Re: BBC's Review of Kentucky Mountain Power, LLC Site Assessment Report for Proposed
Merchant Power Generation Facility in Knott County, Kentucky

Case No. 2002-00149

**Review and Evaluation of
Kentucky Mountain Power
Site Assessment Report**

Kentucky State Board on Electrical Generation and Transmission Siting
211 Sower Boulevard
P.O. Box 615
Frankfort, Kentucky 40602

**Exhibit C-1.
General Location of
Utility Routes Serving KMP**

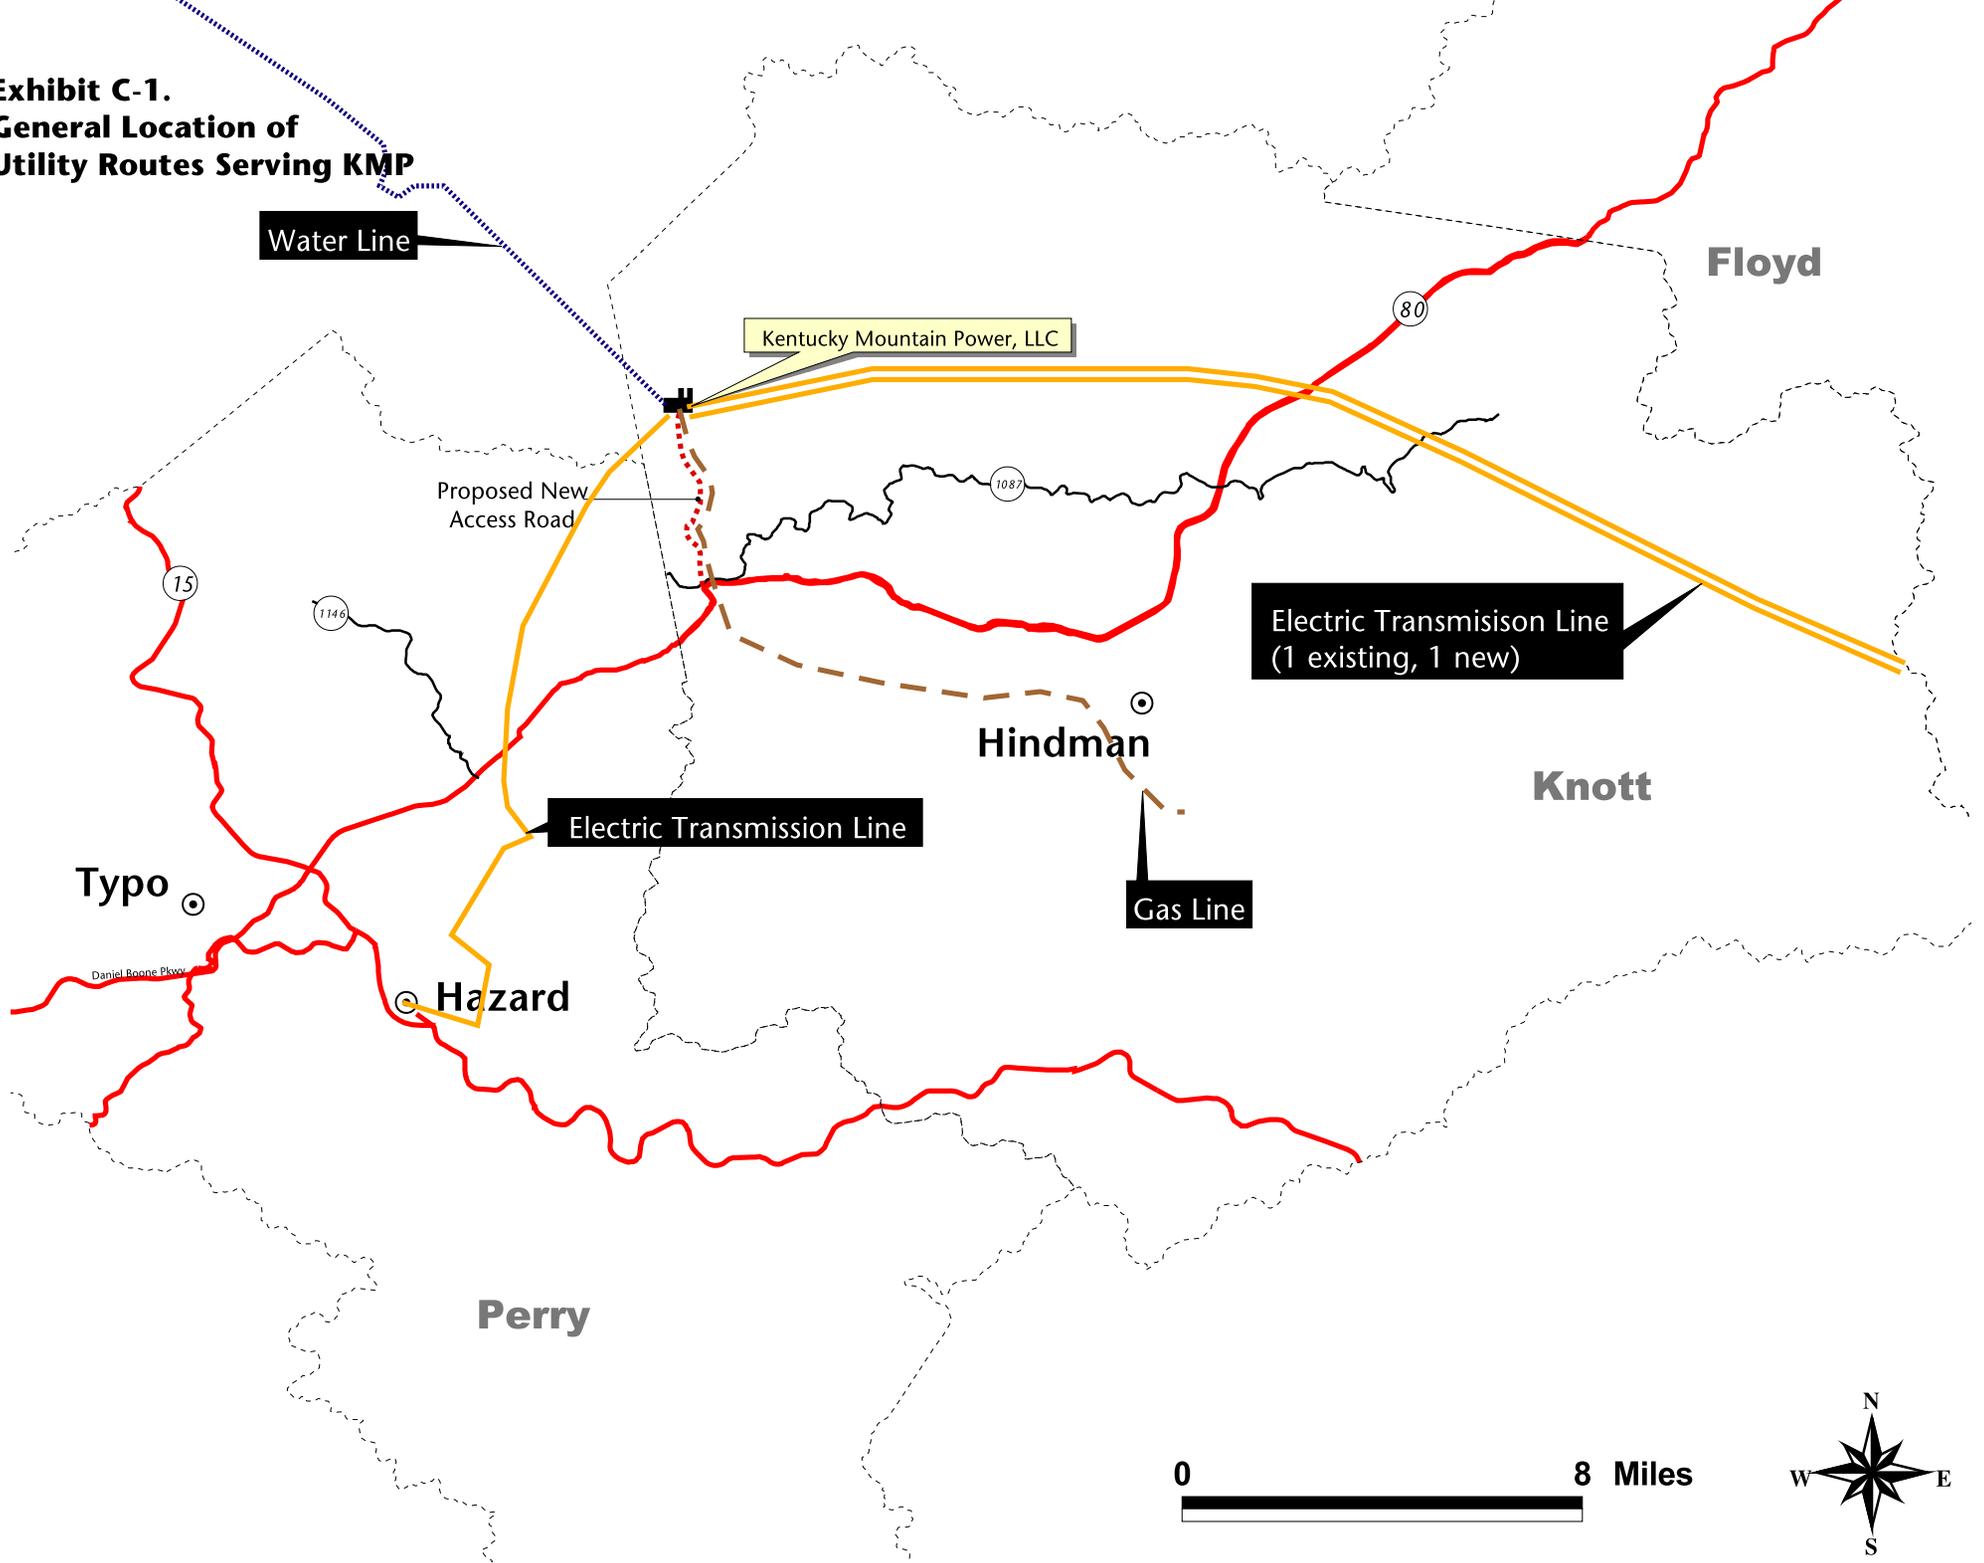
Apart from water and wastewater features within the leasehold, the proposed water system will also require a pumping station on the North Fork of the Kentucky River and approximately 19 miles of buried pipeline to reach Starfire Mine, plus four more miles of pipeline from the edge of the mine property to the power plant site. While the BBC team was unable to visit the full conveyance route, we did visit the location of the proposed pumping station. This facility would be located north of Kragon, along KY 15. The location is along a relatively deserted stretch of river, and it appears there is probably only one existing structure within 500 feet of the proposed pumping station. This structure, an occupied home, would be separated from the proposed pumping station by the KY 15 roadway and, at present, dense vegetation. The study team estimates this home is approximately 200 to 400 feet from the location of the proposed pumping station.

Exhibit C-1 illustrates the general routes of gas, electric and water lines to the site.

- Agreements for most utility services appear to be in place, with the exception of a formal agreement on natural gas service to the plant site. Presumably, Equitable Energy will comply with all state and federal requirements for constructing and operating the gas line to the site, including any required mitigation. The extensive water conveyance system envisioned for this facility includes a riverside pumping station and 19 miles of 30-inch buried pipeline. Impacts of these related facilities, if any, should also be subject to this SAR.

1. KMP should modify their definition of the "site" to include additional portions of their leasehold in order to meet the setback requirements in the legislation and to fully contain the access control fence surrounding the plant.
2. The applicant should modify their access control and security plans to follow industry standards, as described earlier.
3. The water pumping plant should be designed and constructed to minimize its visibility and noise from KY 15 and the existing residence located in the area. Enclosing the pumps within a fully enclosed building, including internal noise baffling, and minimizing visibility by developing an appropriate exterior to the pumping plant and maintaining vegetative screening to the extent possible should minimize any impacts associated with this facility.

**Exhibit C-2.
Kentucky Mountain Power
Primary Traffic Routes and
Baseline Traffic Counts**

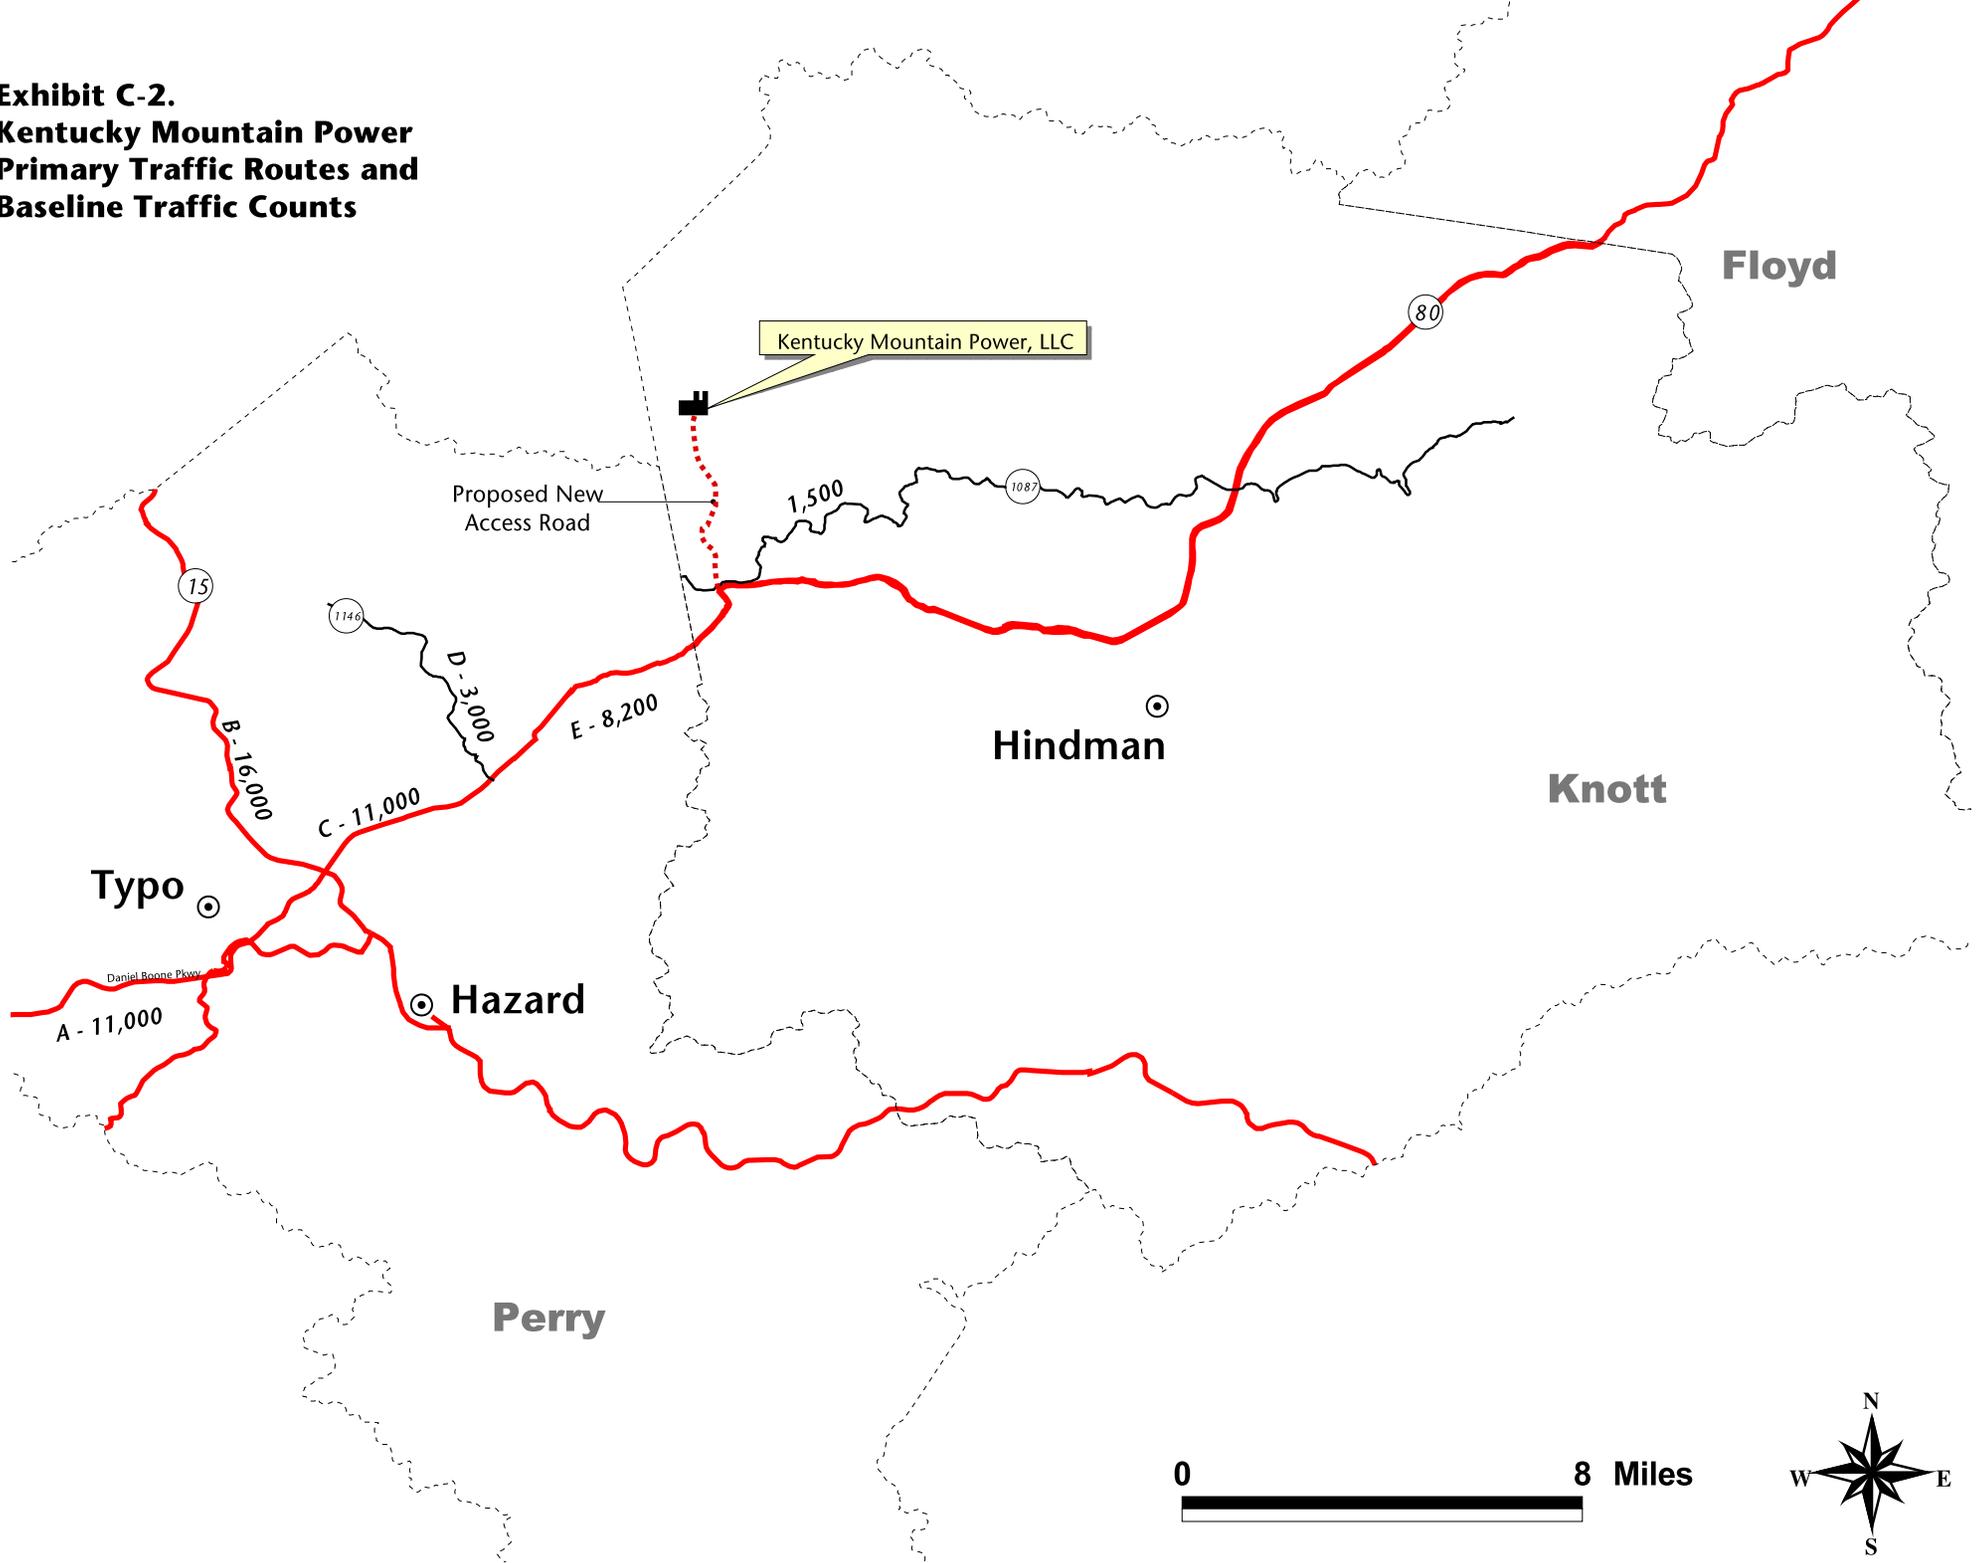
Exhibit C-2, on the following page, depicts the primary transportation routes for fuel and limestone in the vicinity of the proposed plant site. For purposes of assessing the range of potential transportation impacts later in this section of the report, the BBC team has developed two scenarios. The first scenario assumes that most of the fuel required by the plant will be procured from the Starfire Mine, with the exception of waste fuel sources already under contract. The second scenario assumes the worst case, from the standpoint of potential transportation impacts, that no fuel is obtained from the Starfire Mine. These subsequent impact assessments examine baseline traffic conditions and projected increases in traffic along key segments of the road system proximate to the proposed site and labeled A through E on Exhibit C-2.

Exhibit C-2 depicts the most recent daily traffic counts on the primary access routes to and from the plant site. Traffic along KY 80 ranges from about 8,200 vehicles per day in the segment containing the future access route to the plant site upward to nearly 11,000 vehicles per day in the segments east and west of the interchange with KY 15. Traffic along the segment of KY 15 immediately north of the interchange with KY 80 averages as much as 16,000 vehicles per day.⁴⁶
